STAFF REPORT SAN CLEMENTE PLANNING COMMISSION

SUBJECT: **General Plan Amendment 19-291, Specific Plan Amendment 19-292, Pier Bowl Specific Plan Update**, a request to: 1) review and discuss amendments to the Centennial General Plan, an update of the Pier Bowl Specific Plan, and the certification of Addendum No. 3 to the General Plan Environmental Impact Report; and 2) continue this item to October 16, 2019.

Figure 1-5
**General Plan
 Overlays**

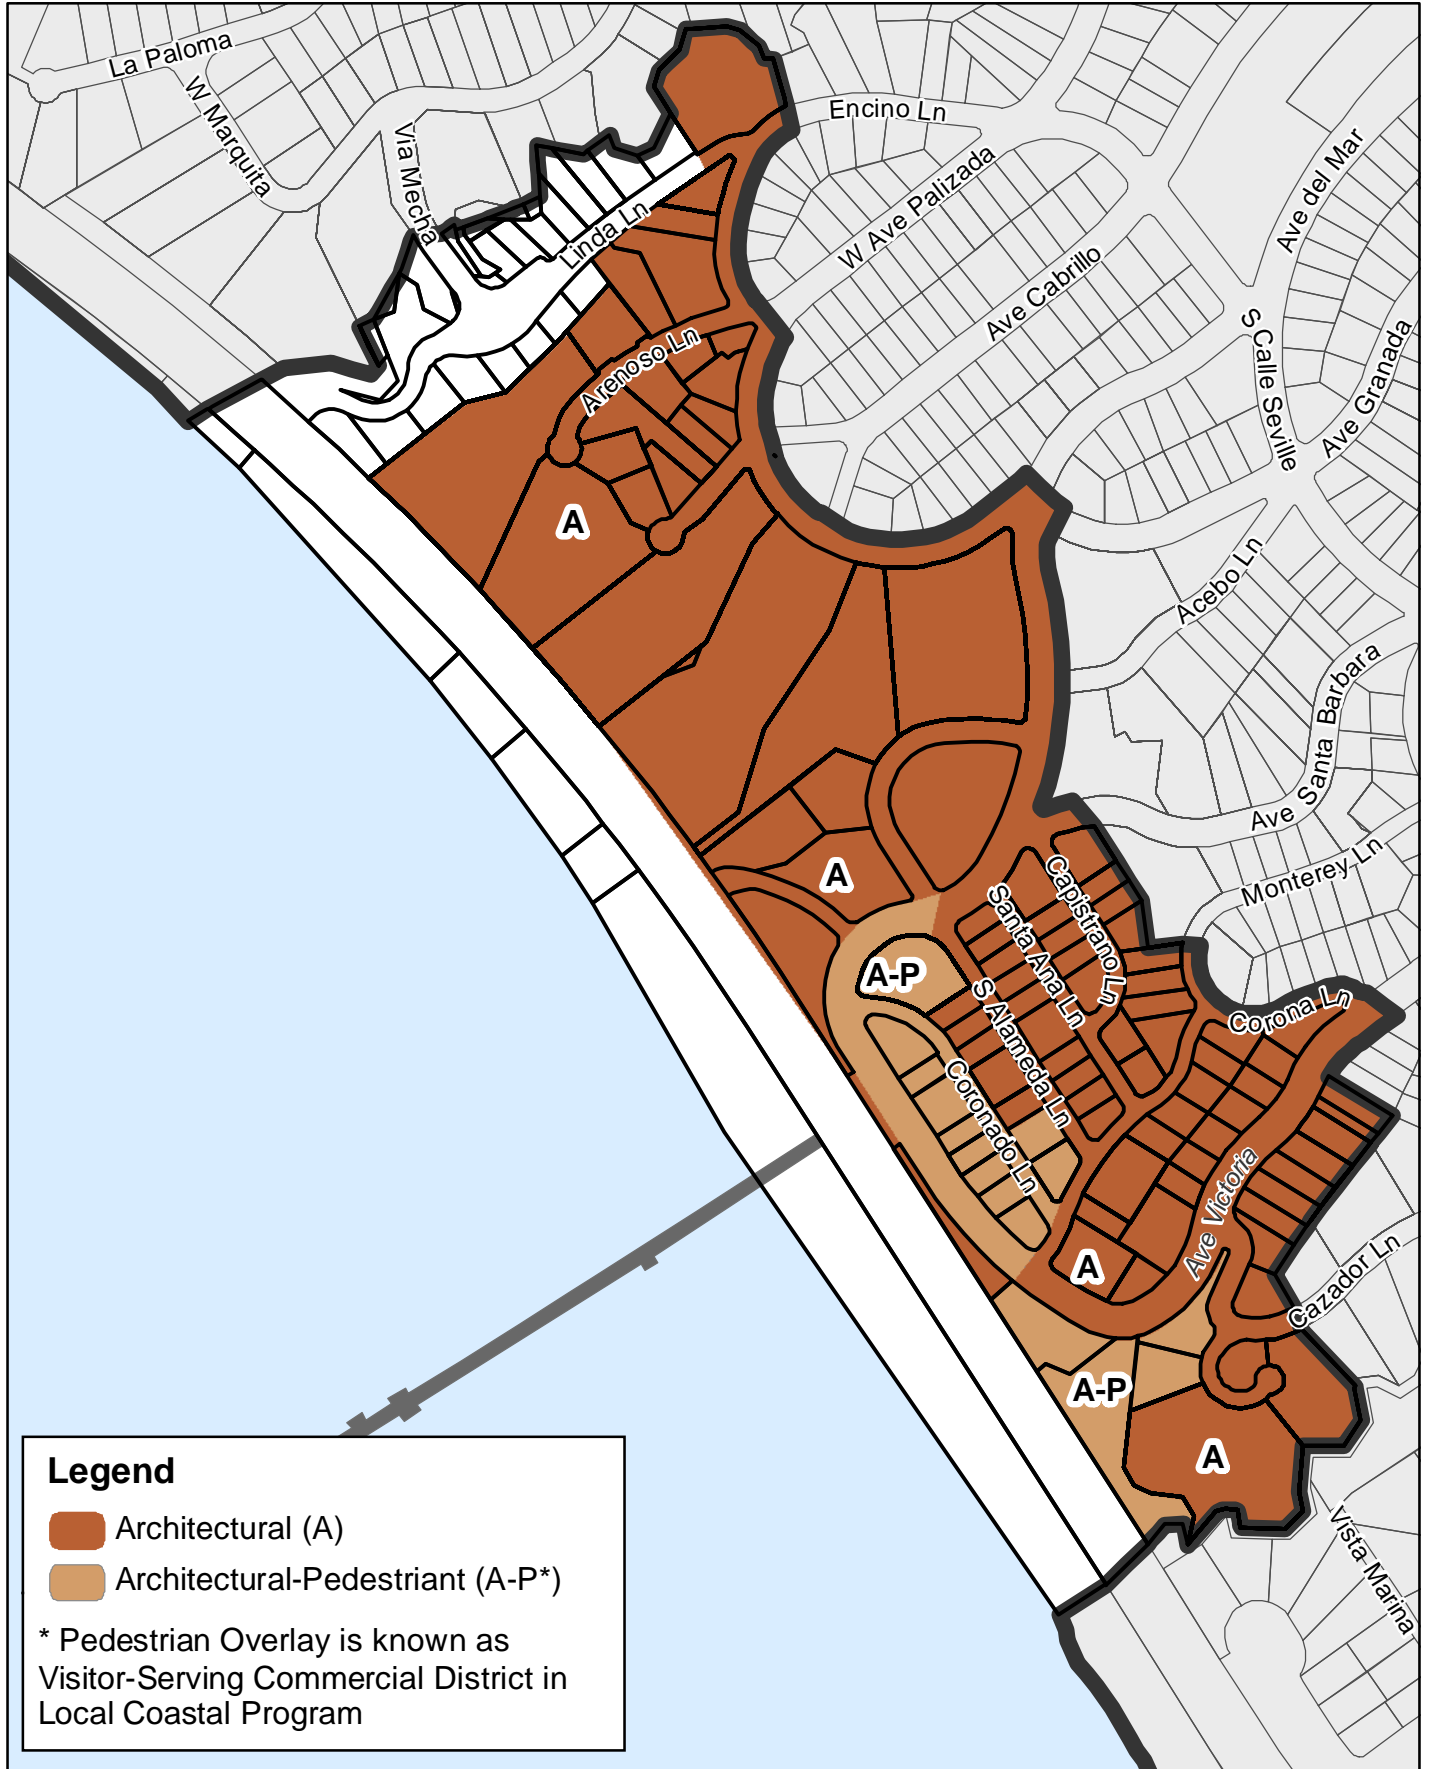
Figure 1-5 should be identical to Figure 2-2. I think 2-2 is the one that needs to be revised (assuming the plan is to show the “bookend” parcels on Coronado as post GP update and in the A-VSC Overlay).

Figure 2-2
Specific Plan
Overlays

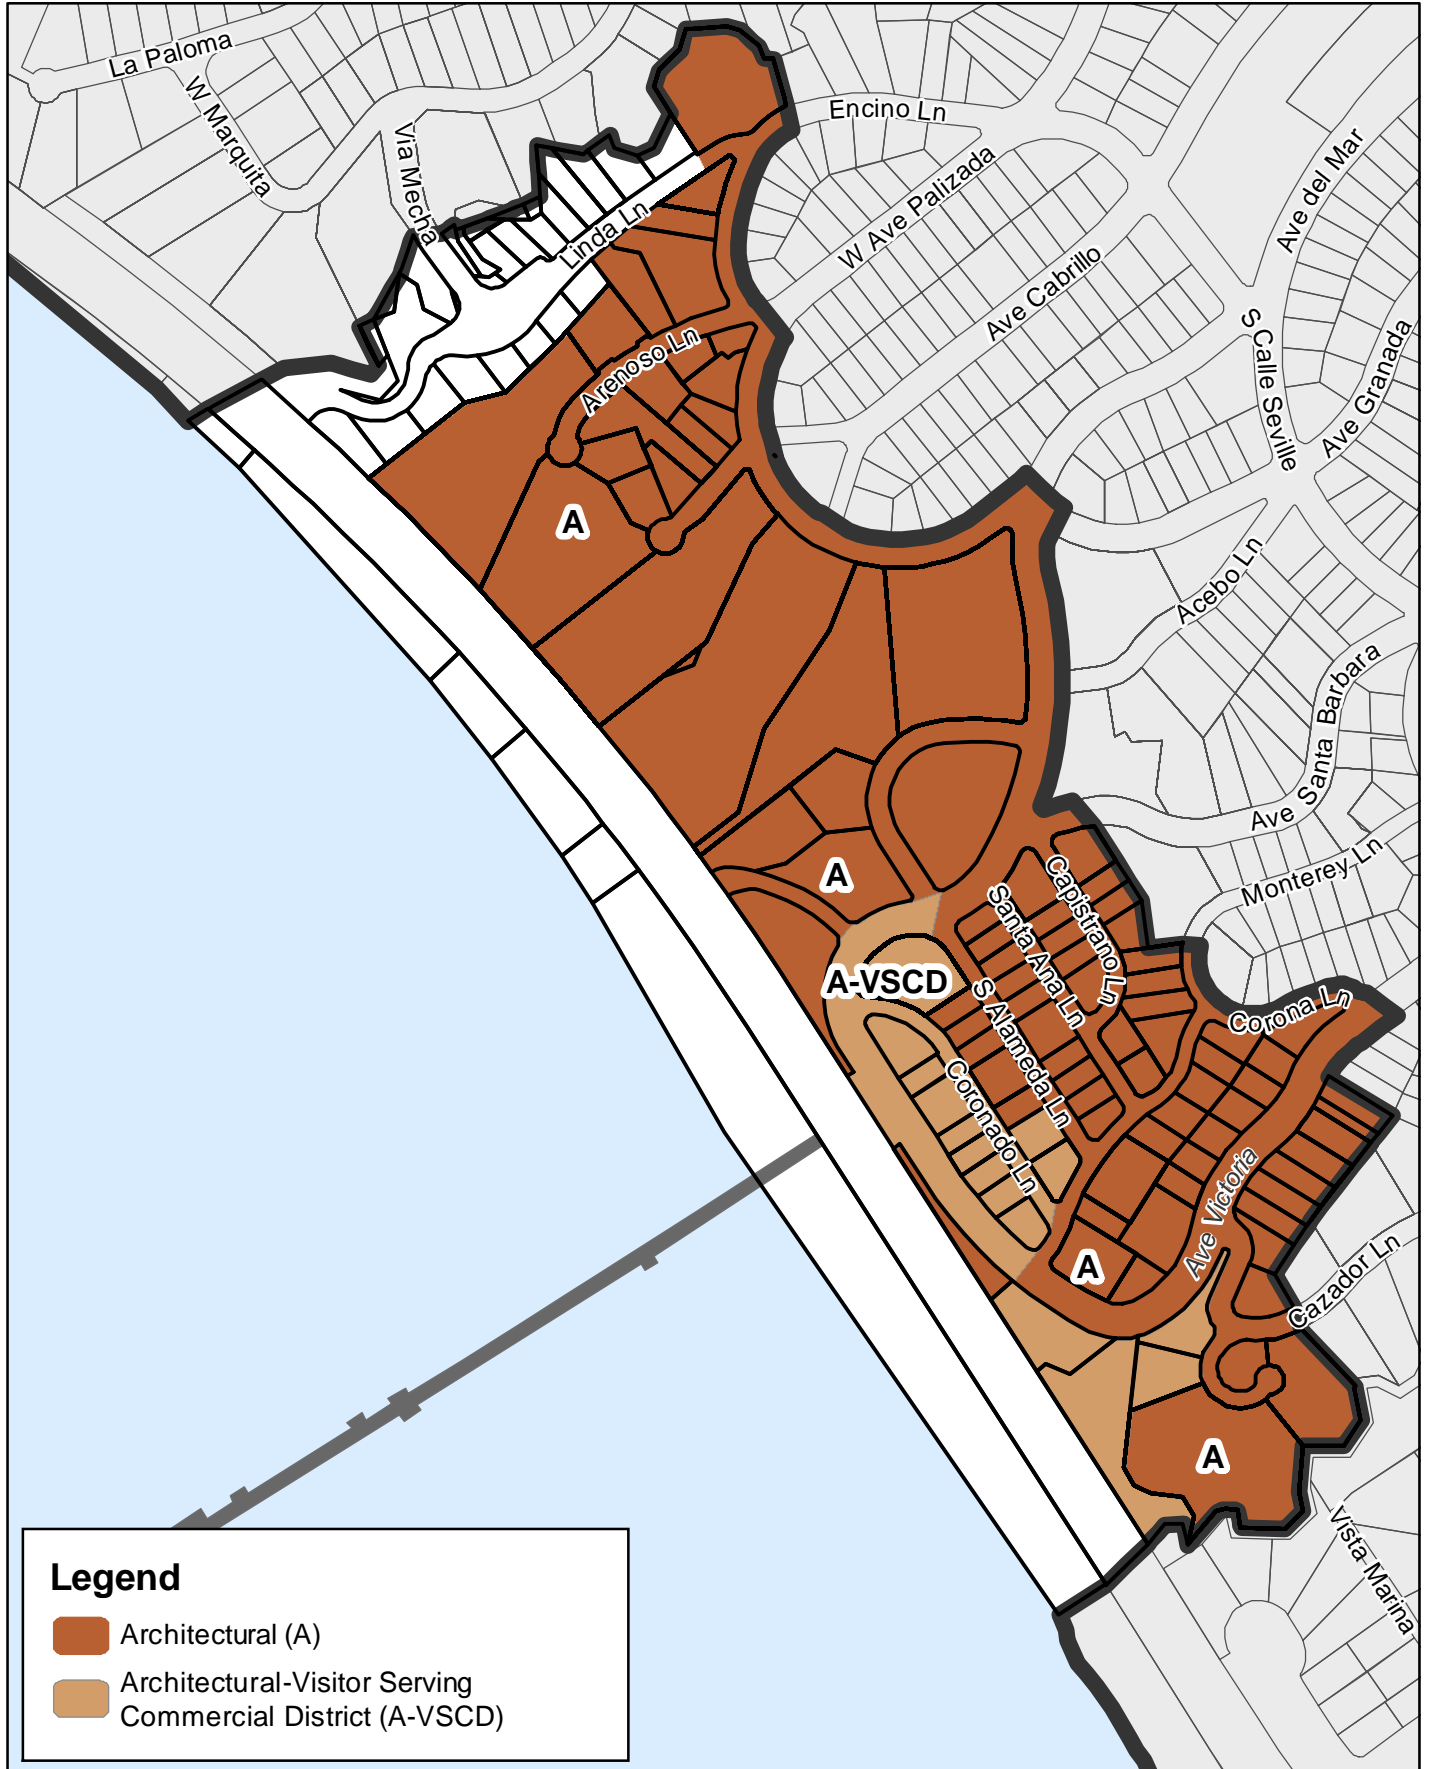
17	2	Figure 2-2 Specific Plan Overlays	2-5	Changed the boundary of the Pedestrian Overlays Overlay to align with the boundary of the Mixed Use 4 area and the VSCD Overlay in the LUP
18	2	Figure 2-2 Specific Plan Overlays	2-5	Removed the Pedestrian Overlay from the Public designated areas in the General Plan consistent with the Coastal Land Use Plan, including the Casa Romantica site, the municipal parking lot, and Parque Del Mar along Avenida Victoria
19	2	Figure 2-2 Specific Plan Overlays	2-5	Removed the Pedestrian Overlay from the Public Open Space (OS1) designation of the “Alameda Lane” property (where Park Semper Fi is located) to reflect overlays in the General Plan and LUP
20	2	203 Affordable Housing Program	2-11	Updated description of affordable housing program and references to reflect current state law

Figure 2-3
Open Space

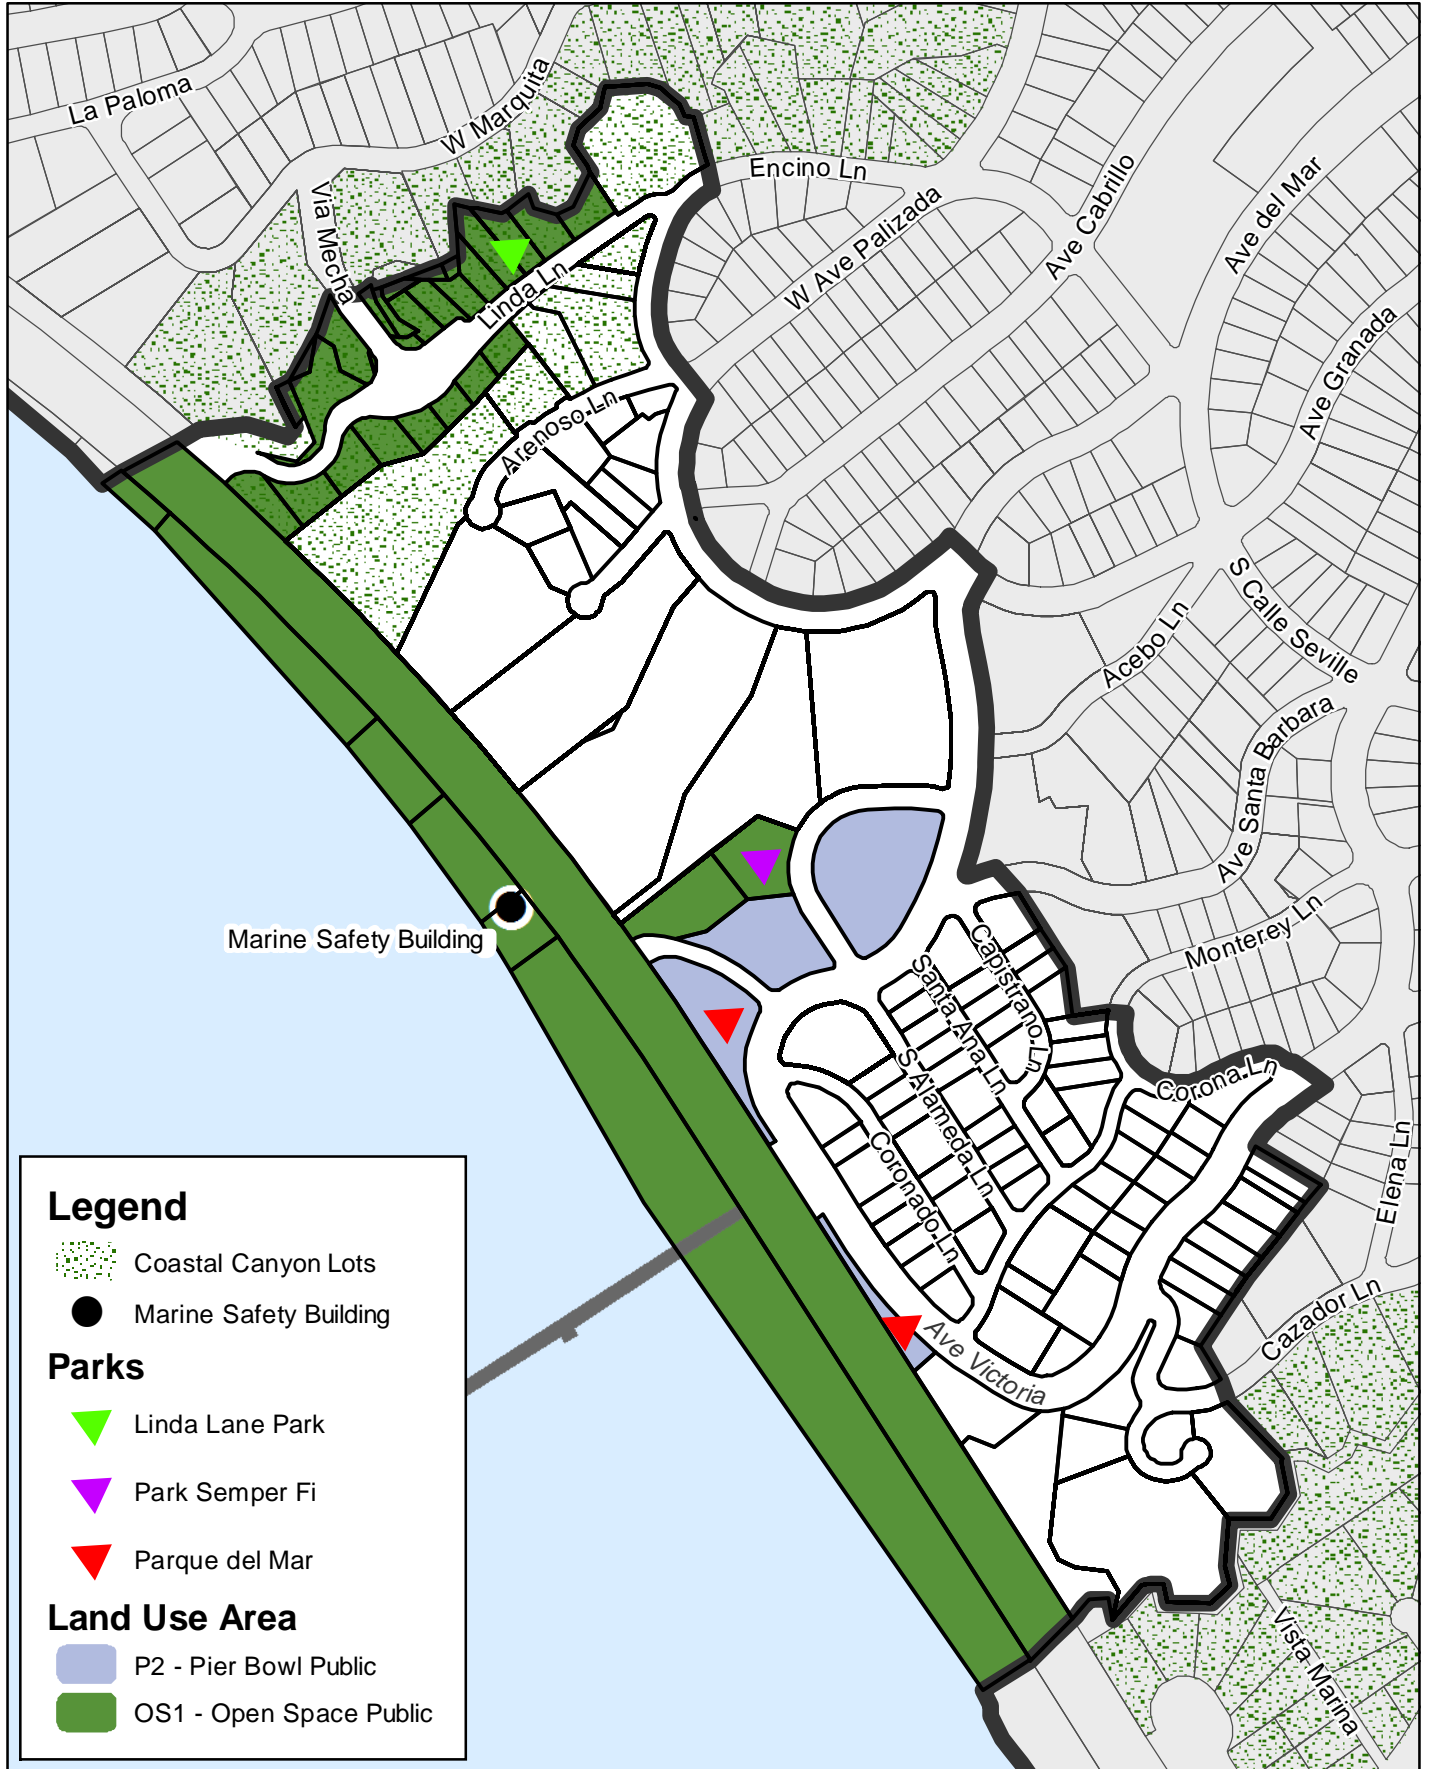
Re Figure 2-3 (and this is something I've been harping on for some time in other contexts), the stipple to represent "Coastal Canyon" should really be intended to designate a "Coastal Canyon Overlay" because the limits of the pertinent canyons do not correspond to the stipple. In the case of Trafalgar Canyon, the stipple covers lots that don't even have a square inch in the canyon—for example the lots on Cristobal southeast of the cul-de-sac. Moreover, there are lots within the Pier Bowl SP that do not show any canyon stipple even though substantial portions of the lots are within the canyon (not stippled because the lots are in the PBSP and as such the zoning provisions of the Coastal Canyon Overlay aren't applicable unless specifically made applicable).
